## ADDENDUM #9

**Western Slope Food Bank of the Rockies**  
698 Long Acre Drive

**Bid Package #4 – Above Ground**

Architect's Project No. 2108

HOOD DETAIL

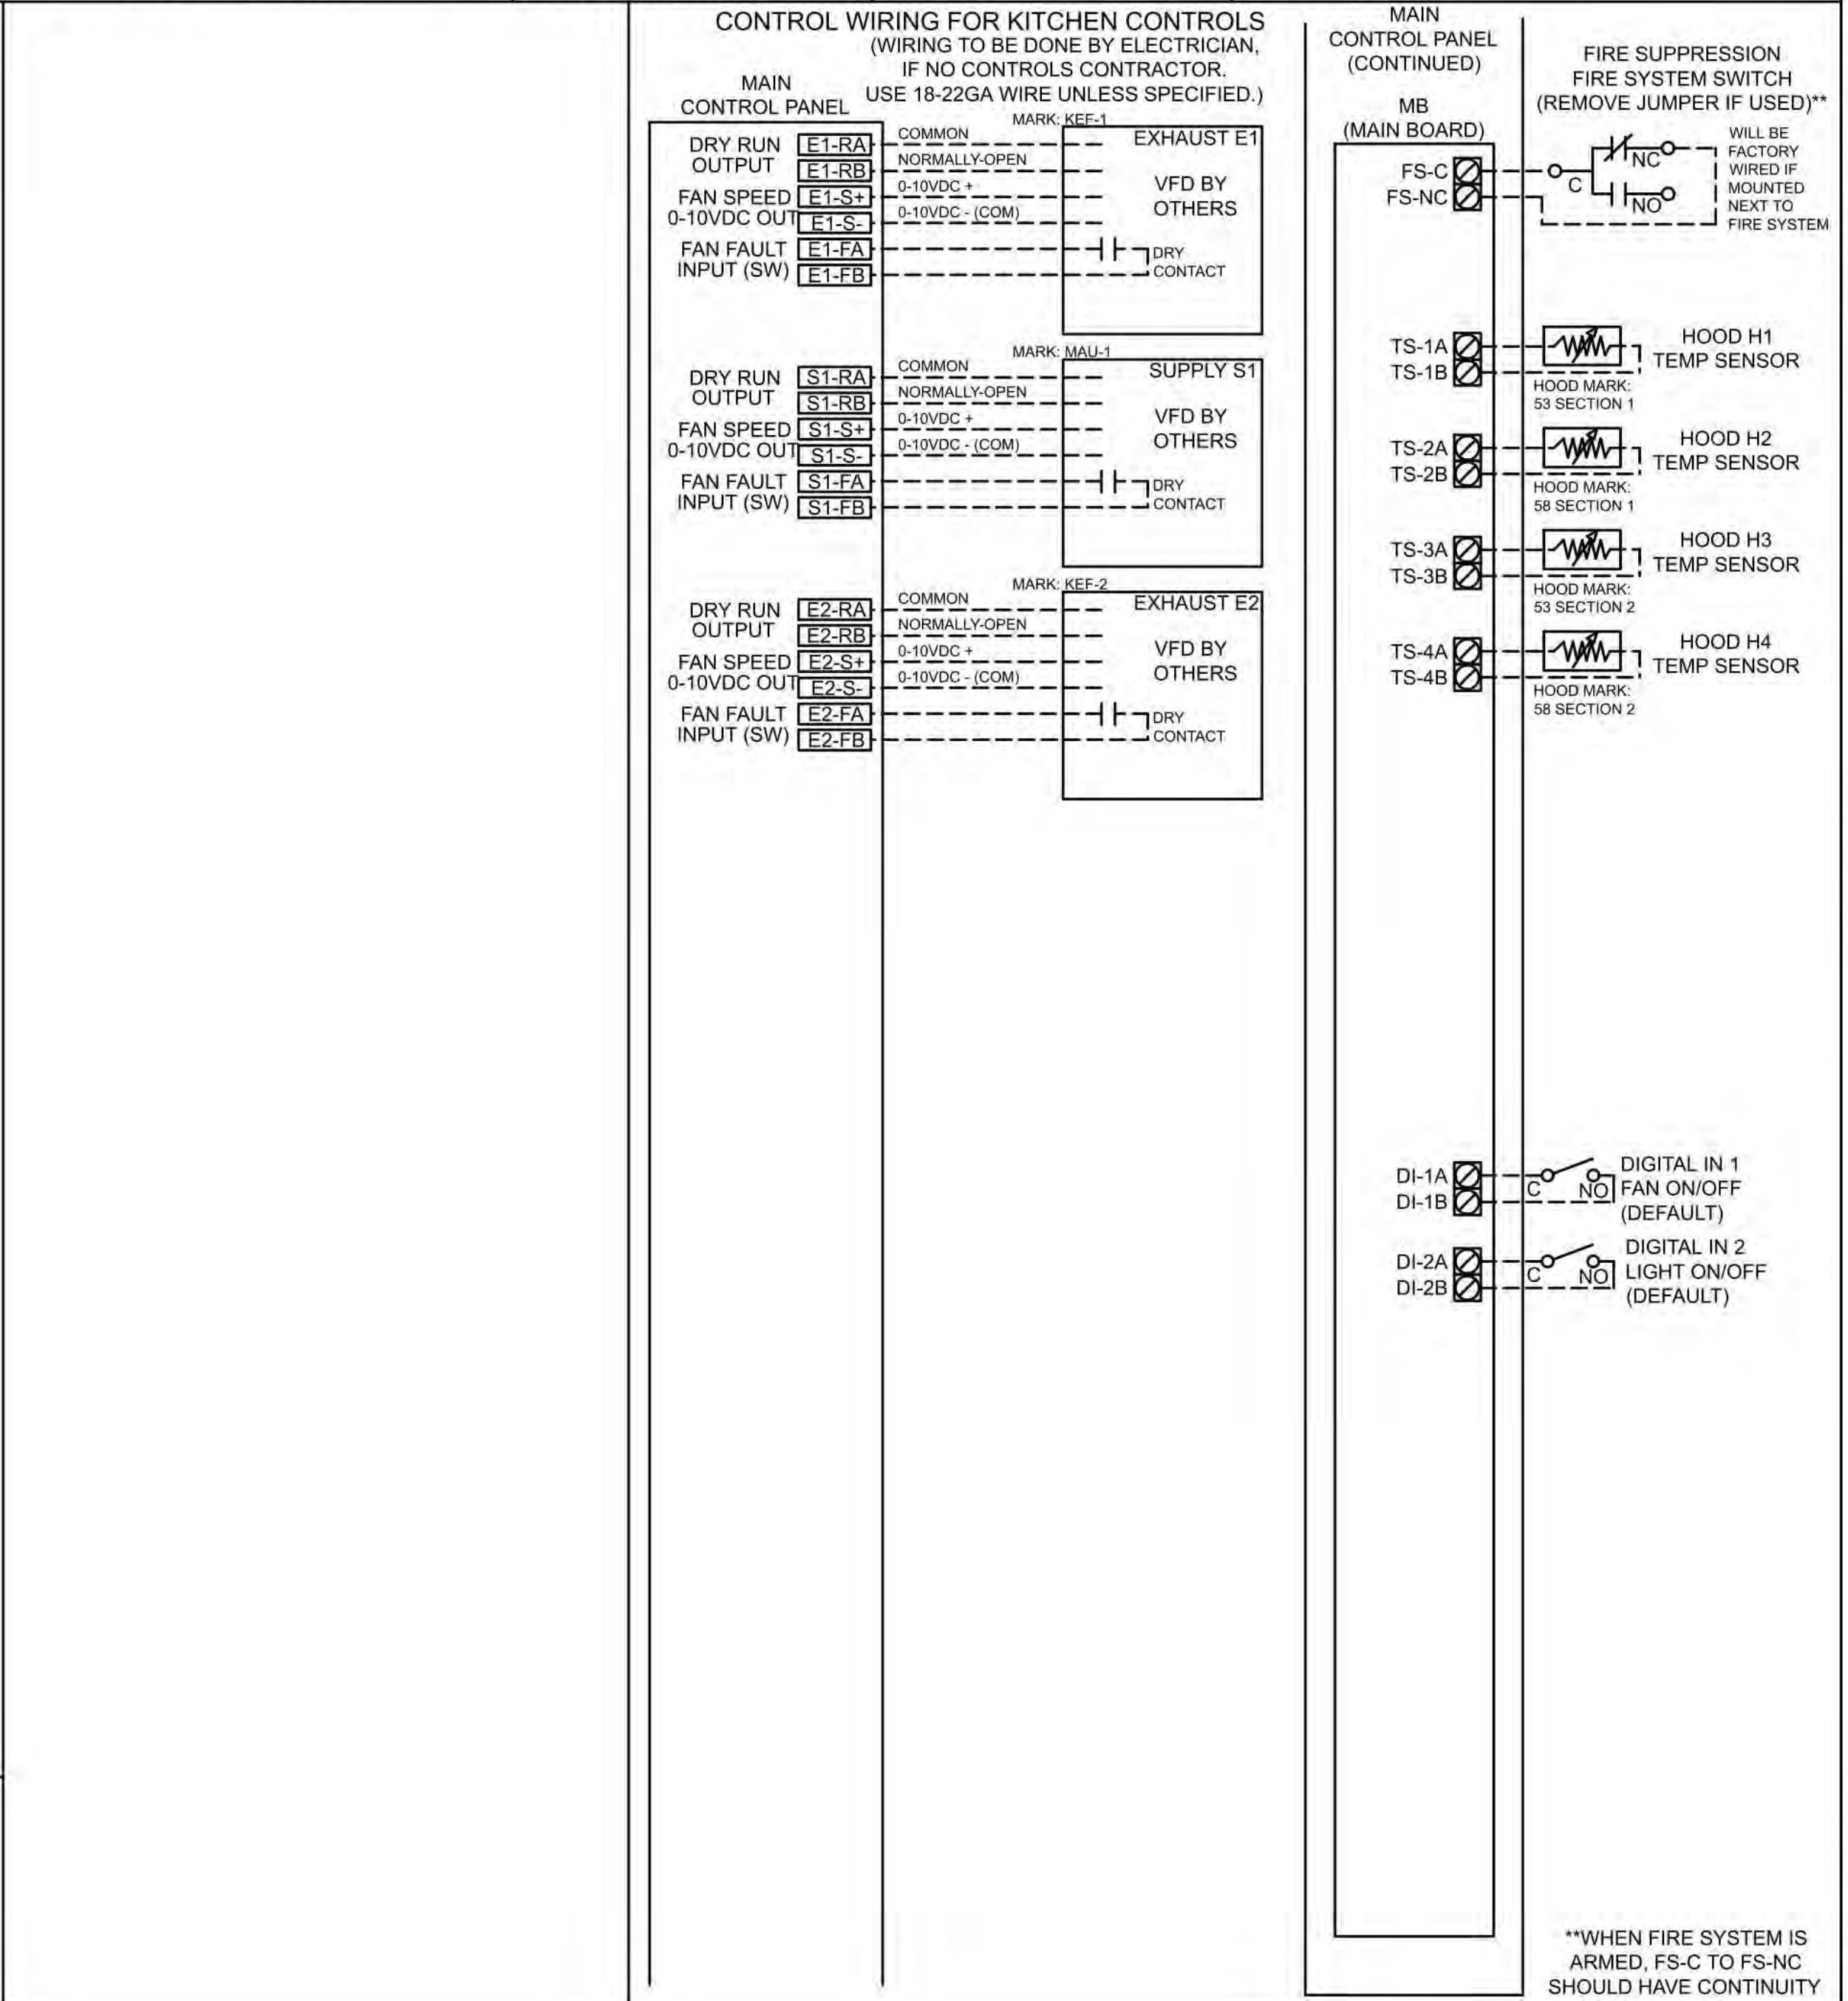
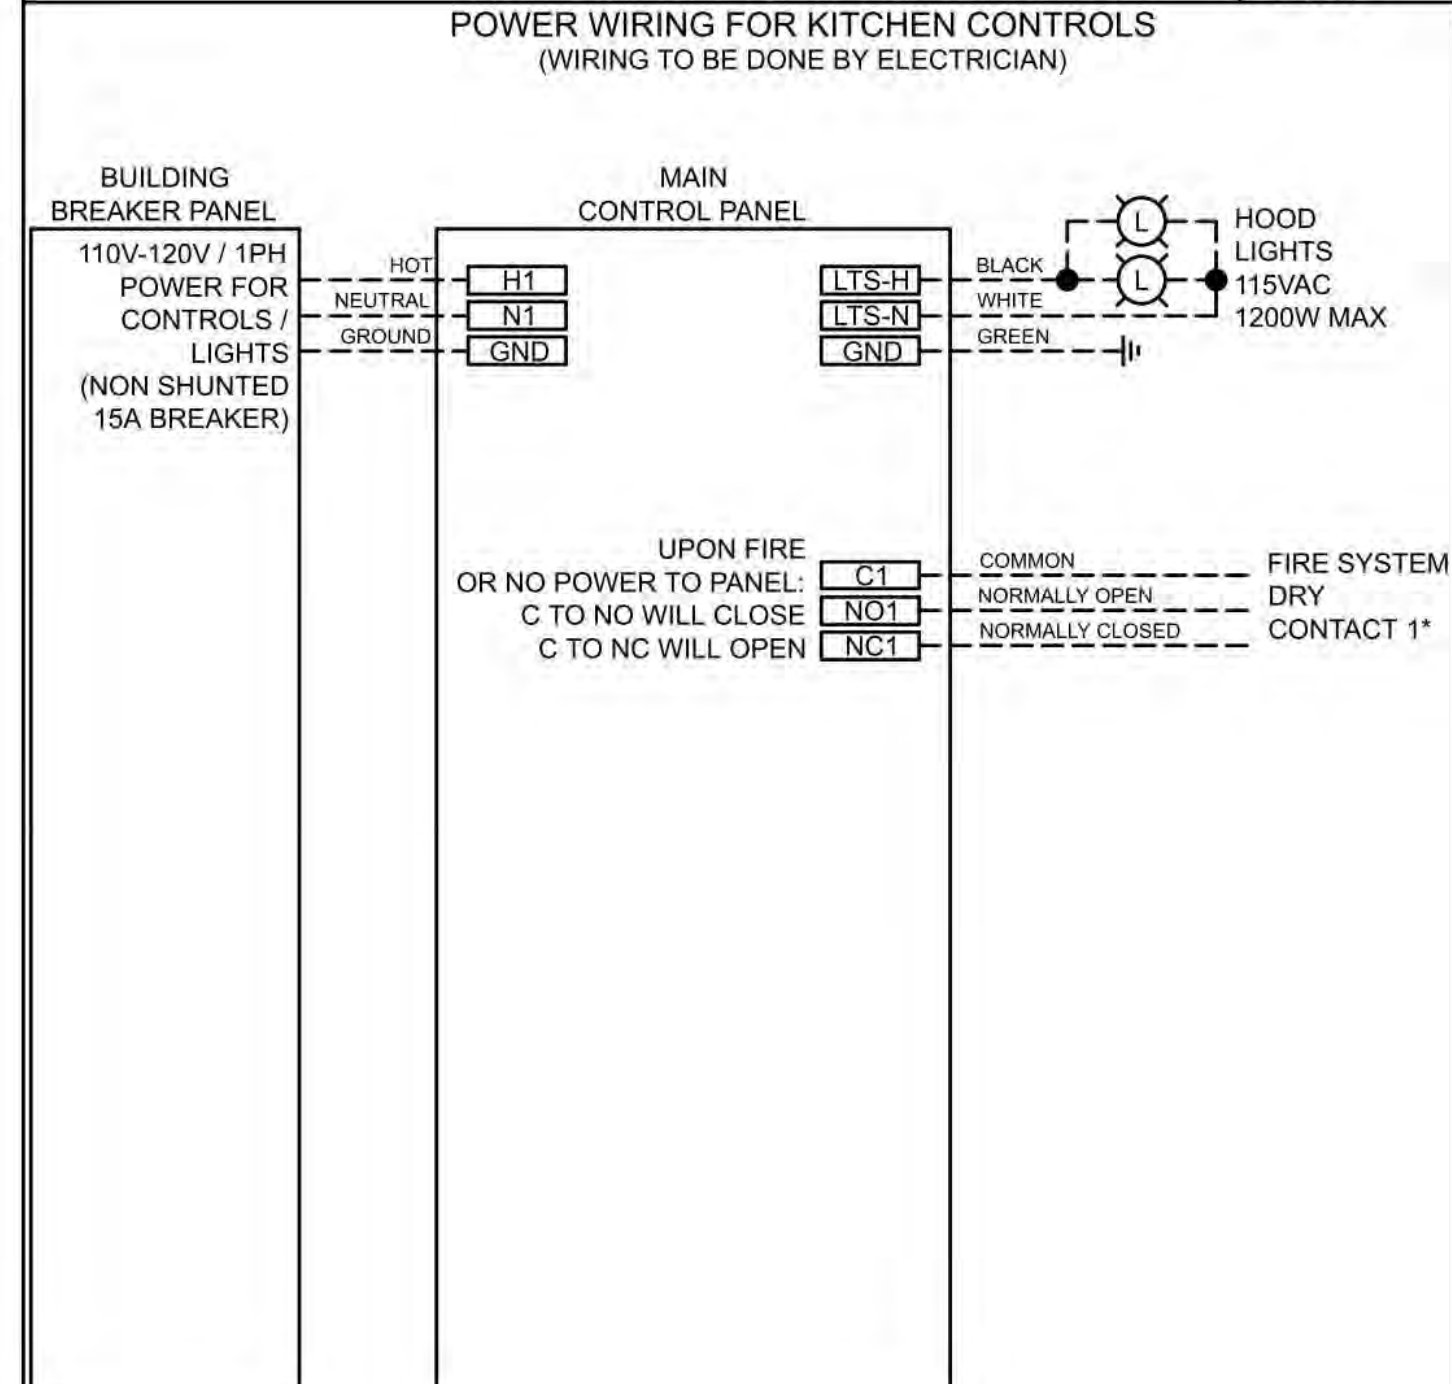
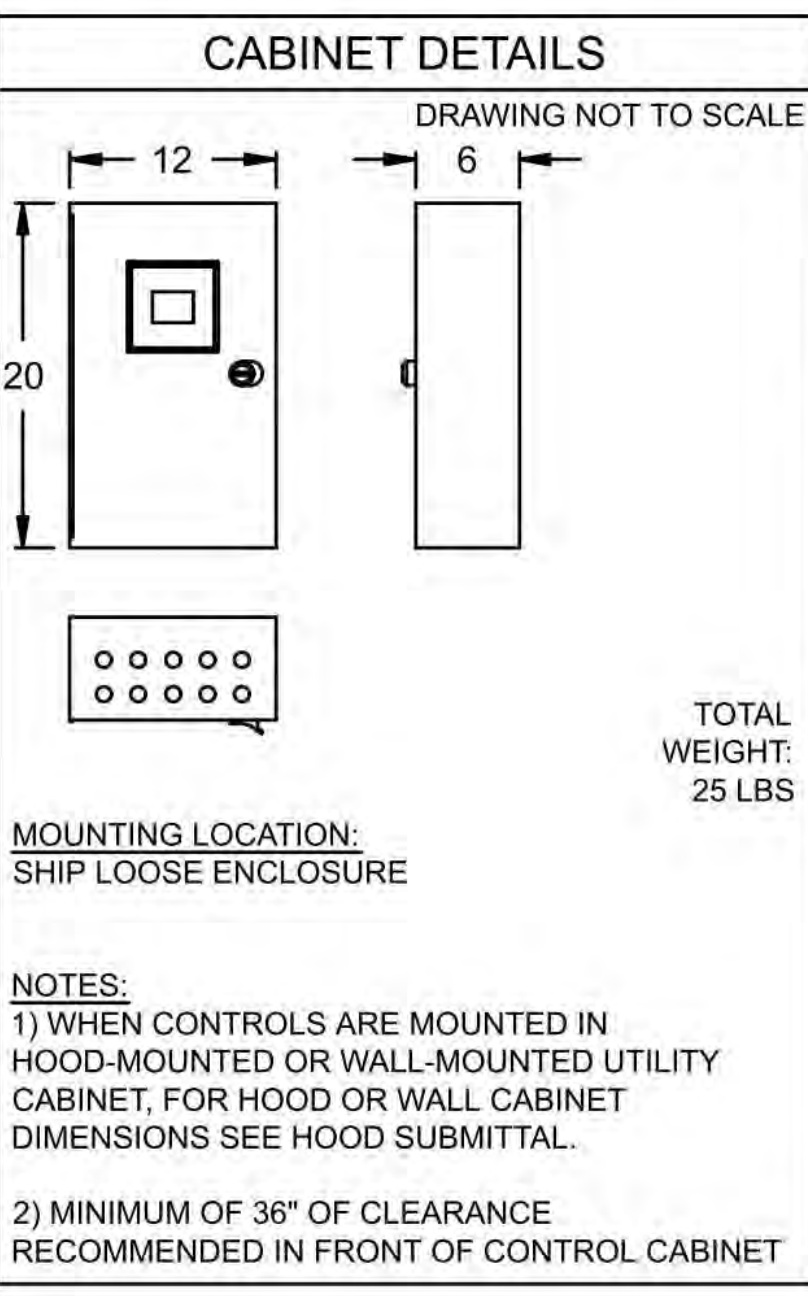
THE KITCHEN HOOD ASSEMBLY, FIRE SUPPRESSION SYSTEM, CONTROLS AND RELATED ACCESSORIES AS SHOWN OR SPECIFIED OR REQUIRED FOR COMPLETE AND FUNCTIONAL SYSTEM SHALL BE PROVIDED (FURNISHED AND INSTALLED) UNDER THIS CONTRACT.
